DEVIATION REQUEST AND DECISION FORM

Project Name : Sanctuary of Peace Residential Community
 Schedule No.(s) : 7103001034
 Legal Description : A portion of the SW quarter of Section 27, T11S, R66W of the 6th PM, El Paso County, Colorado.

This request is to allow installation of sidewalk on one side of the roadway where both sides are required by the ECM.

PRIVATE ROAD SECTION (PROMISE POINT)

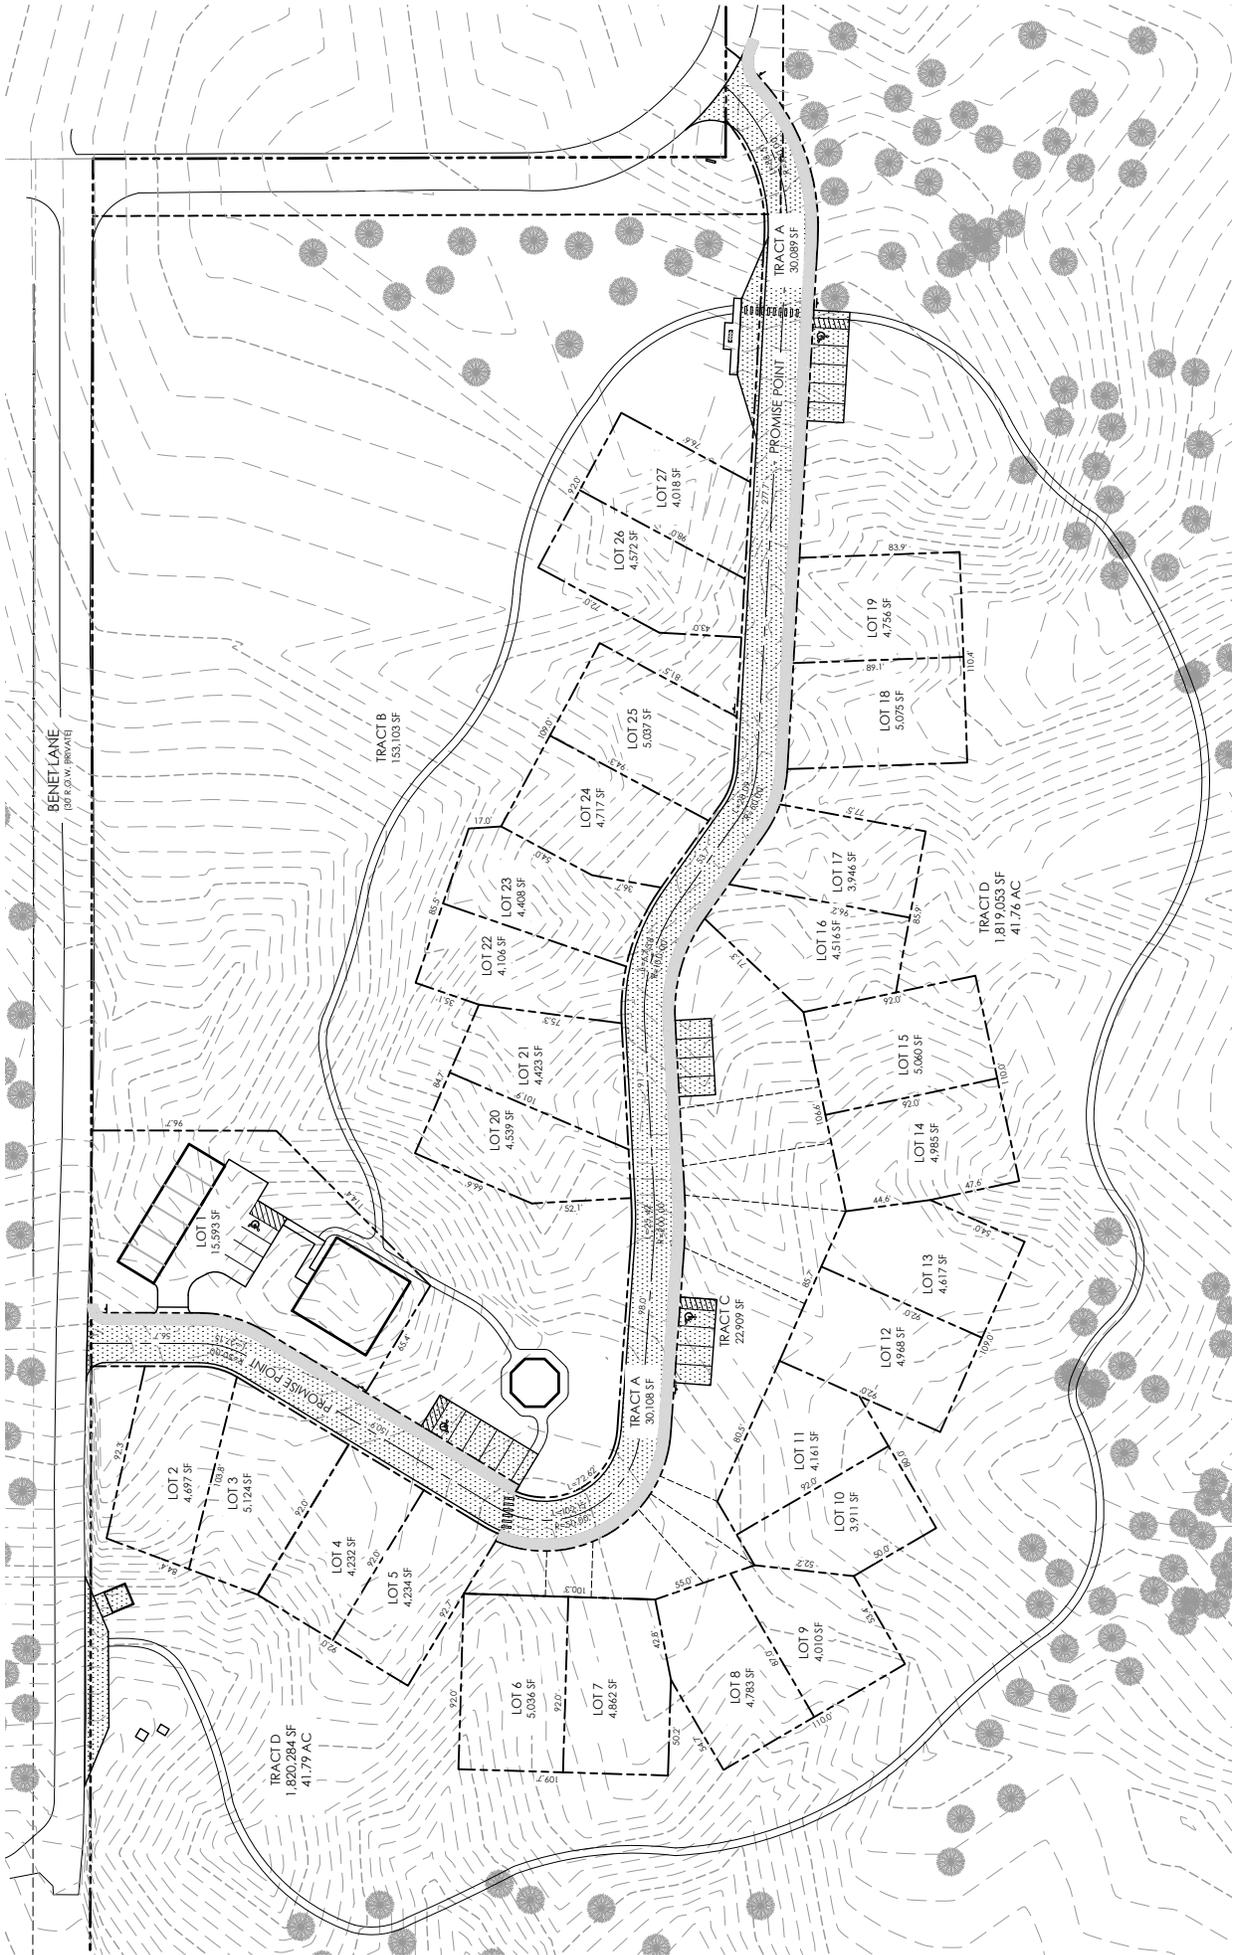
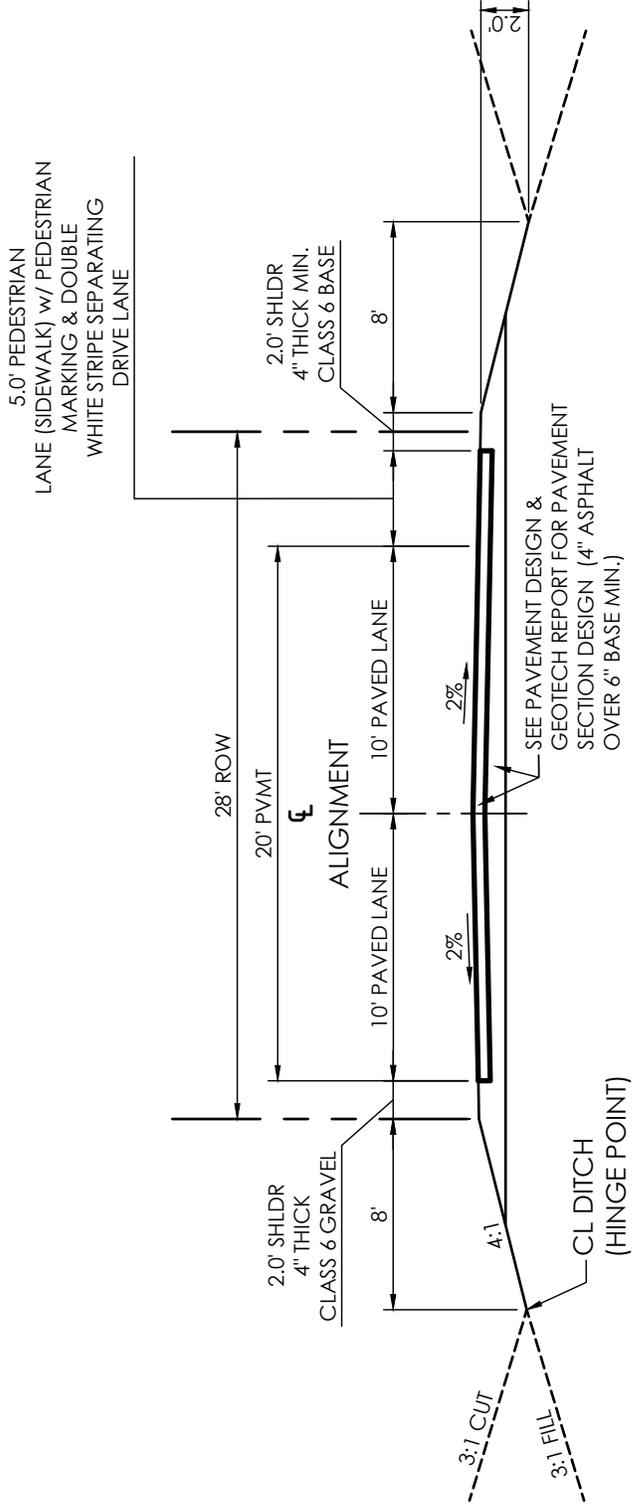
2.5.2.B.3 *"Sidewalks shall be installed on both sides of the road."*

The proposal is to provide for pedestrian access within the residential area of Sanctuary of Peace PUD with asphalt sidewalks along one edge of the private paved roadway. The roadway, being a reduced-width low-speed private road, is intended to coincide with the character of Benet Lane that connects to the proposed road in two locations. The intent is to preserve the existing forest trees, vegetation and landforms within the site as much as possible. Sidewalk on one side will provide adequate pedestrian access within the site which is very traffic volume and not a thoroughfare to any other locations.

This request has been determined to have met the criteria for approval. A deviation from Section 2.4.2.B.2 of the ECM is hereby granted based on the justification provided.
